Los Angeles Regional Water Quality Control Board

October 18, 2022

SUBJECT: REVIEW OF INTERIM REMEDIAL ACTION PLAN FOR SITE GROUNDWATER, PURSUANT TO CALIFORNIA WATER CODE SECTION 13304 CLEANUP AND ABATEMENT ORDER NO. R4-2021-0079

SITE: SKYPARK COMMERCIAL PROPERTIES (ASSESSOR PARCEL NO. 7377-006-906), 24701 – 24777 CRENSHAW BOULEVARD AND 2530, 2540, AND 2600 SKYPARK DRIVE, TORRANCE, CALIFORNIA (SCP NO. 1499)

FIGURE 6

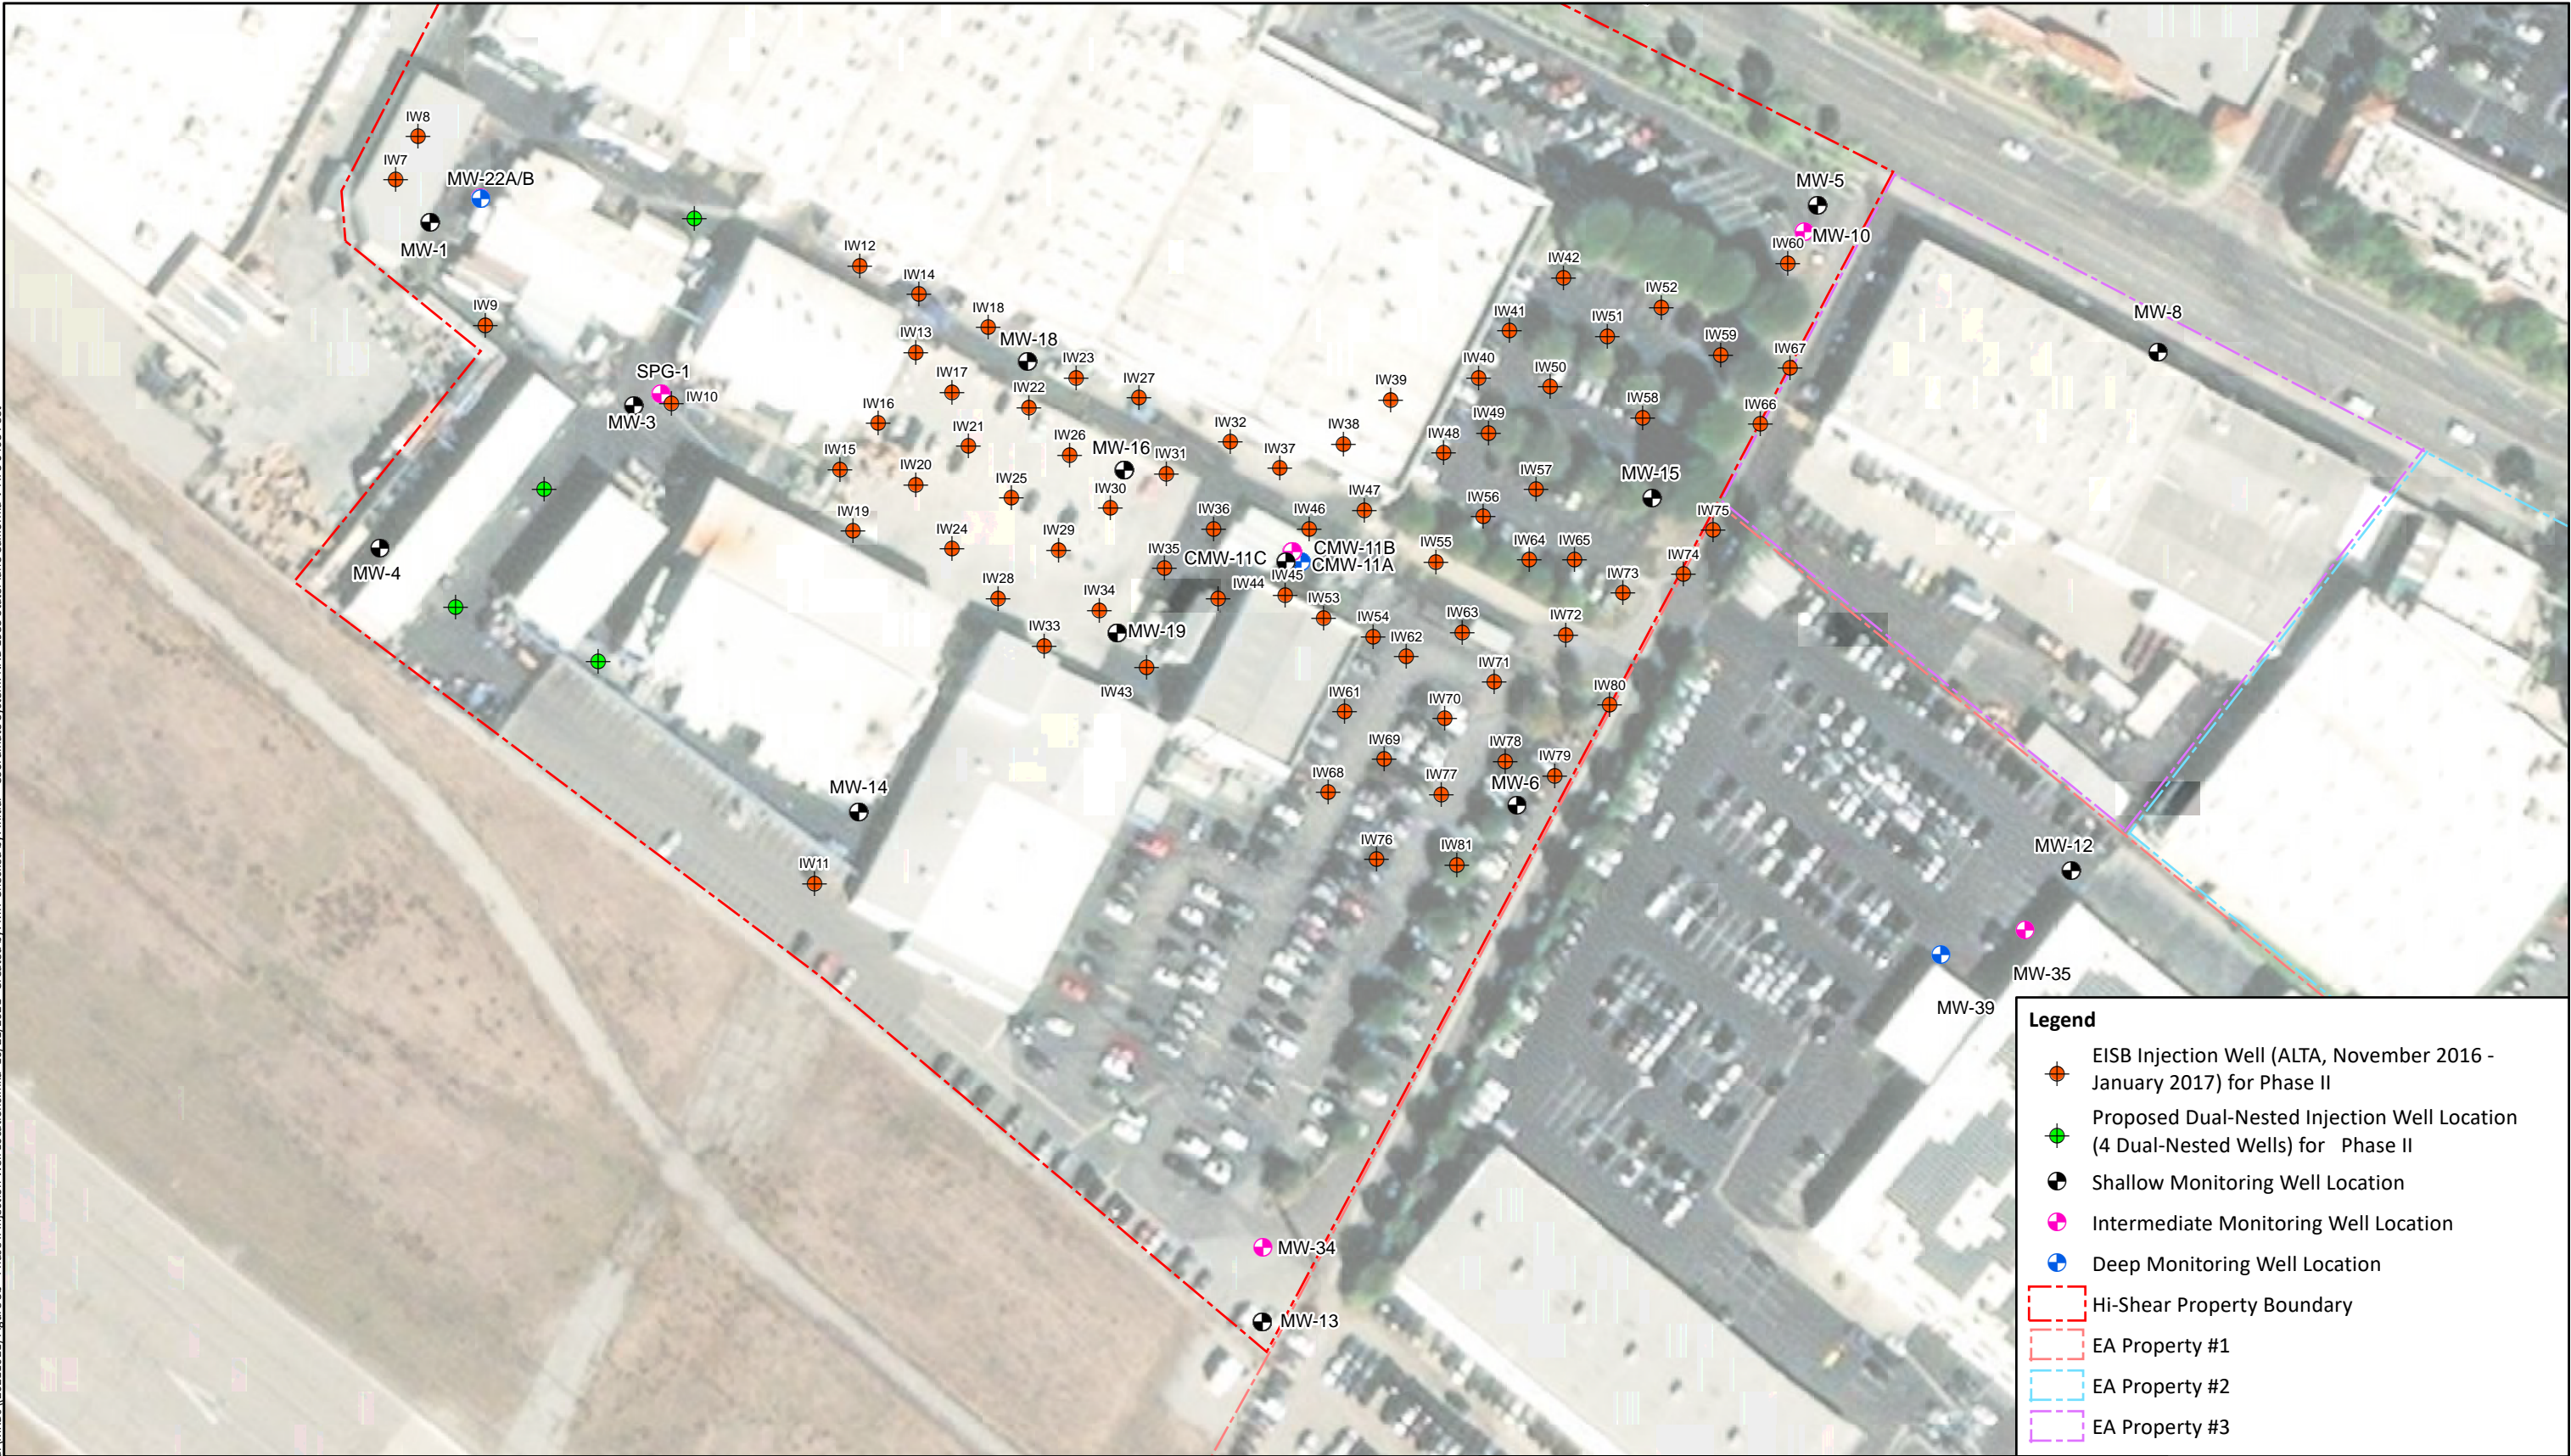
1. ZVI Barrier
 - a. Intends to minimize the migration of the VOC plume into the City of Lomita and to reduce groundwater contaminant concentrations.
 - b. Is located roughly along the eastern boundary of the Site (i.e., along Crenshaw Boulevard) and measuring approximately 500 feet (see attached Figure 6 – Plume Margin ZVI Barrier) to treat groundwater total VOC concentrations greater than 200 micrograms per liter (µg/L).

- c. Is installed by injecting ZVI, KB-1 Plus (a commercial bioaugmentation culture), and plant-based substrate (guar) at 28 injection points into a 25-foot zone approximately 90 to 115 feet below ground surface (ft-bgs). The injection points are organized in an array of two rows approximately in the center 250 feet of the groundwater VOC plume with single rows of injection points extending 125 to the north and south. The north and south extent and placement of the ZVI barrier will be better understood with confirmation groundwater samples collected during installation of the outmost injection wells.

- iv. The exact locations of the 28 injection points are subject to change as confirmation groundwater samples will be collected during injection well installations that may better inform placement of injection points.

Comment Identifier	Commenter	Comment Summary	Response
			<p>The ZVI barrier must be extended, based on the most recent groundwater monitoring data and in-field confirmation groundwater samples, which is reflected in the October 18, 2022 RWB letter conditionally approving the GW IRAP.</p> <p>See Comments No. 1, 4, and 6 in the October 18, 2022 RWB letter “Review of Interim Remedial Action Plan for Site Groundwater.”</p>
C.5	Hi-Shear	Hi-Shear and its consultants believe in a comprehensive approach for the Site and area east of Crenshaw Boulevard rather than employing different remedial options in different areas.	<p>The RWB staff concurs with the comment. The RWB have reminded Dischargers of the benefits of collaborating to address investigative and cleanup actions at the Site. Nonetheless, the RWB is willing to approve the interim remedial measures discussed herein, which are designed to substantially reduce concentrations of pollutants beneath the Hi-Shear property as well as in the contaminant plume migrating offsite.</p>

FIGURE 2: Groundwater Well and Soil Gas Probe Location Map

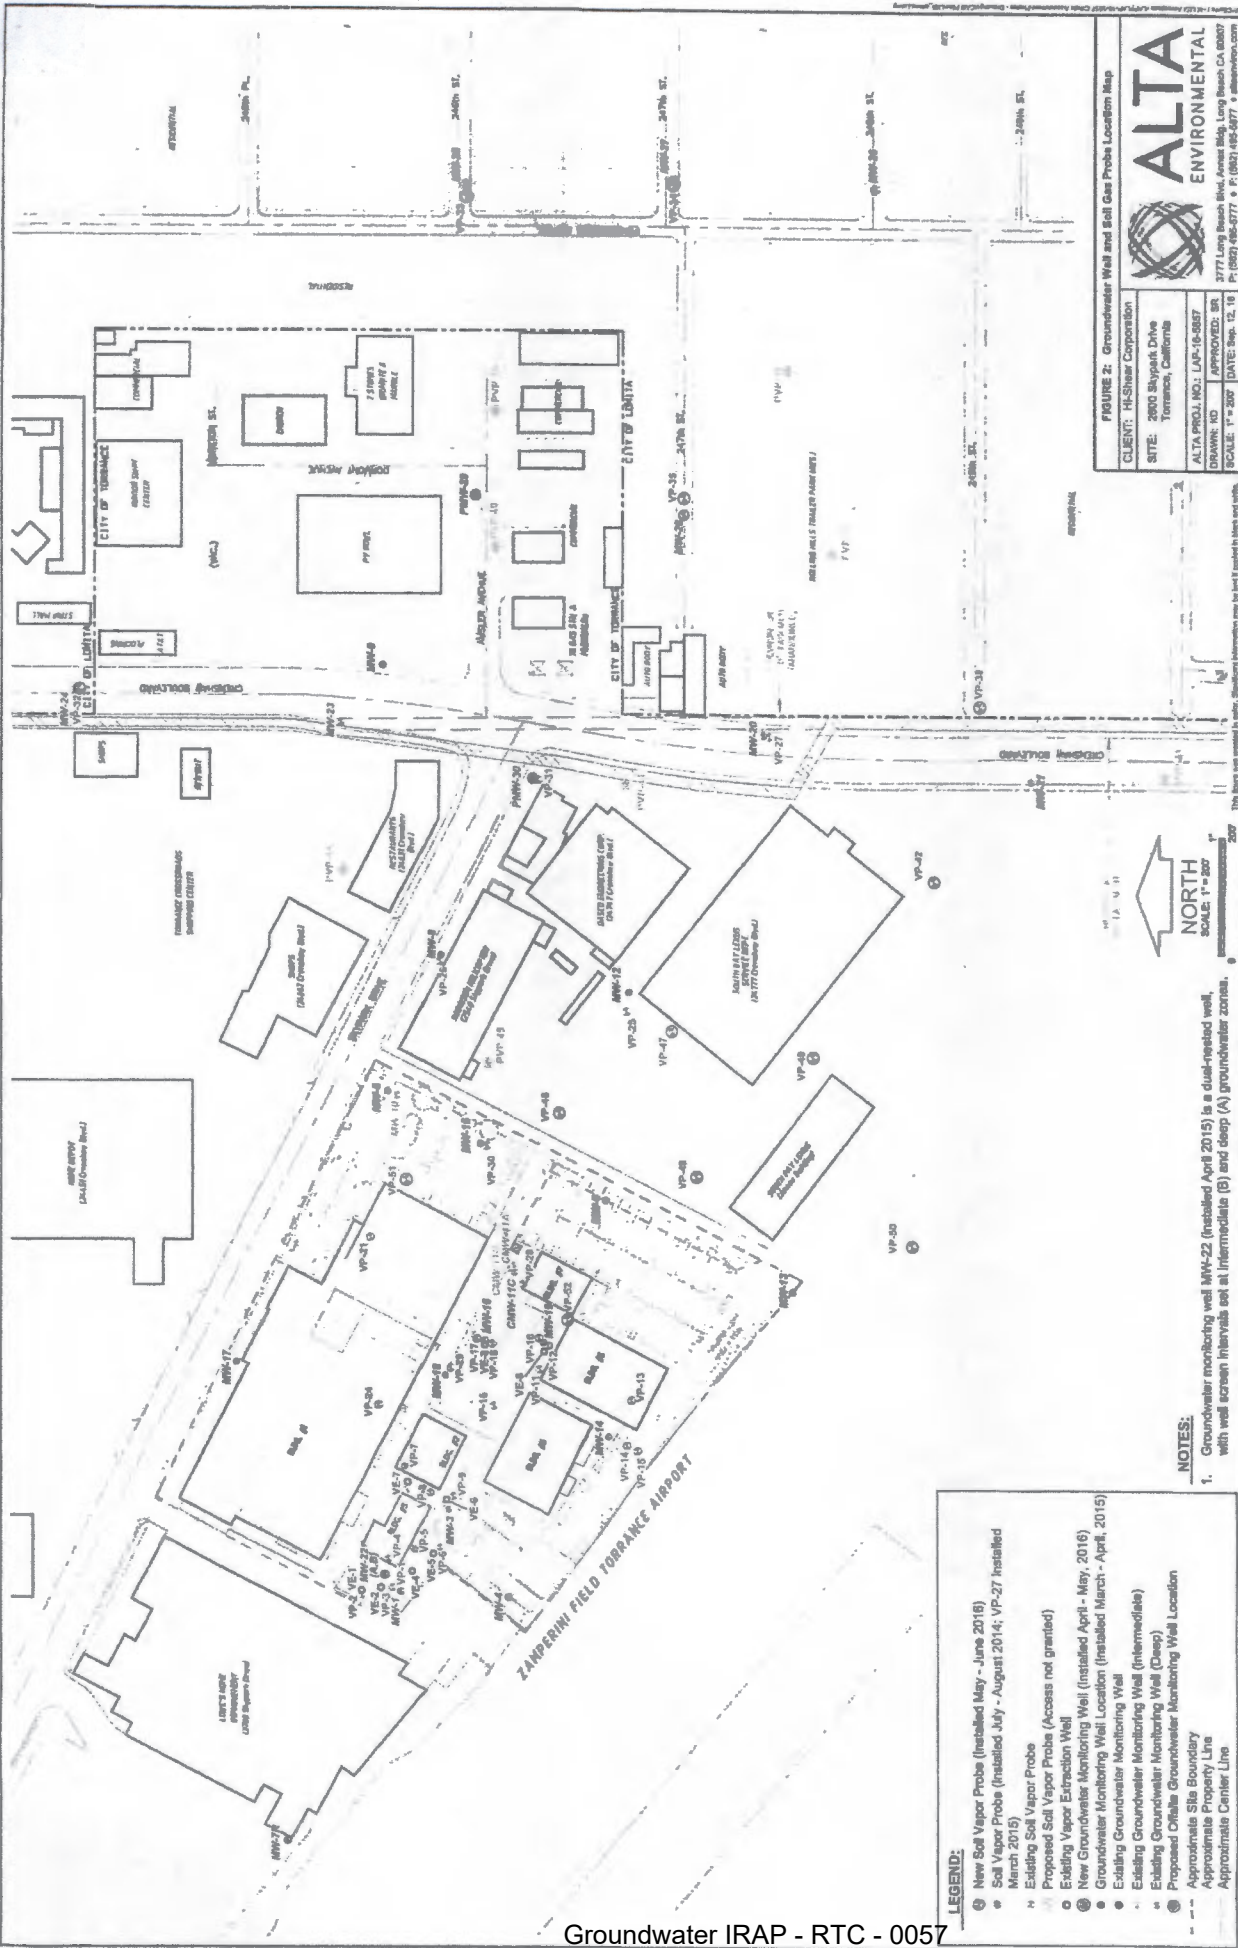
As seen on Figure 8 of the IOAR, and on Figure 3-3 of the Triannual Groundwater Monitoring Report dated January 31, 2018, the onsite groundwater monitoring wells MW-18, MW-16, and MW-6, and the offsite groundwater monitoring wells MW-12, MW-20, and MW-26 are aligned along the east-southeastward trending axis of the TCE plume originating from the Hi-Shear Site. The TCE plume, which originated from the Hi-Shear Site, continues to migrate offsite and downgradient from the Site east-southeastward since 1992, and has crossed past Crenshaw Boulevard and Pennsylvania Avenue. The offsite extent of this Hi-Shear VOC groundwater plume has not been fully delineated.

Figure 3 of Terraphase, 2022, EA RAW

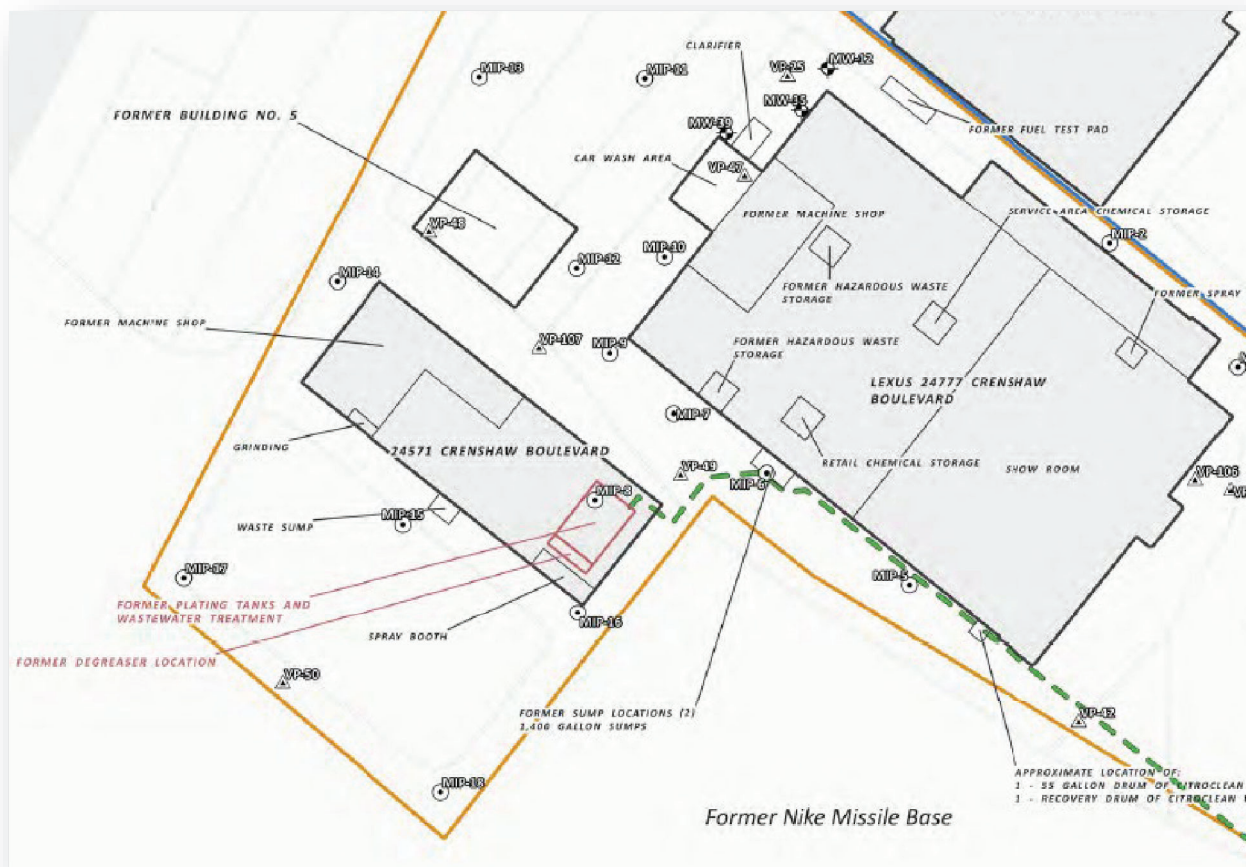
L&K indicates the elevated PCE concentrations in soil samples collected at MIP-8 are anomalous because PCE was detected at higher concentrations in soil samples collected at depths of 15 and 20 feet bgs (1,100 micrograms per kilogram [$\mu\text{g}/\text{mg}$] for both samples) than at 5 and 10 feet bgs (210 and 650 $\mu\text{g}/\text{mg}$, respectively). The available site characterization data indicates a release of PCE and 1,1,1-TCA occurred in the vicinity of MIP-8, but not that MIP-8 was the specific release location. As suggested by Terraphase, additional sampling is warranted to further delineate the area of elevated PCE and 1,1-DCE concentrations in shallow soil to determine the specific location or locations of the release(s). MIP-8 is the only boring advanced within the 24751 Crenshaw Boulevard property and MIP-8 was not located at the former degreaser:

detail to locate a passive groundwater remedy such as a PRB (for example, the shallow hydraulic gradient shown in Figure 3 of the RAW is shown to be in a direction that is nearly parallel (e.g., North-South) to the proposed alignment of the PRB as shown in Figure 4 of the RAW. A design of this type is more prone to failure because of the insufficient capture of the contaminated groundwater as well as the potential for insufficient contact time with the implemented treatment.

As such, the lack of shallow site characterization at Property 1 was correctly identified by Terraphase in the EA RAW as a data gap.
